## Access Compliance Report Public Rights-of-Way (Curb Ramps)

Intersection ID: 3062 Main Street: LOGANVILLE\_DR Cross Street: PROSPERITY\_CHURCH\_RD Location: E

ADA ID: 3F4FC356F8B9 Ramp Type: Directional1 Initial Pass/Fail: Pass Overall Compliance: No Severity Score: 0

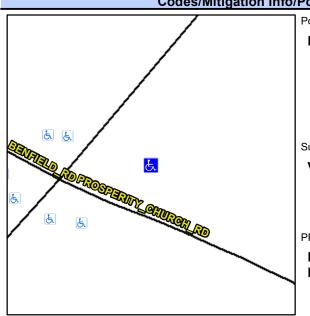
Surveyor Notes:
VEGETATION OVERGROWTH

PROW/ADA:
Not Found, R304.2.2-Perp, R304.3.2-Para, R304.5.2, R305.2

Possible Solutions:
Remove & Replace Entire Ramp.
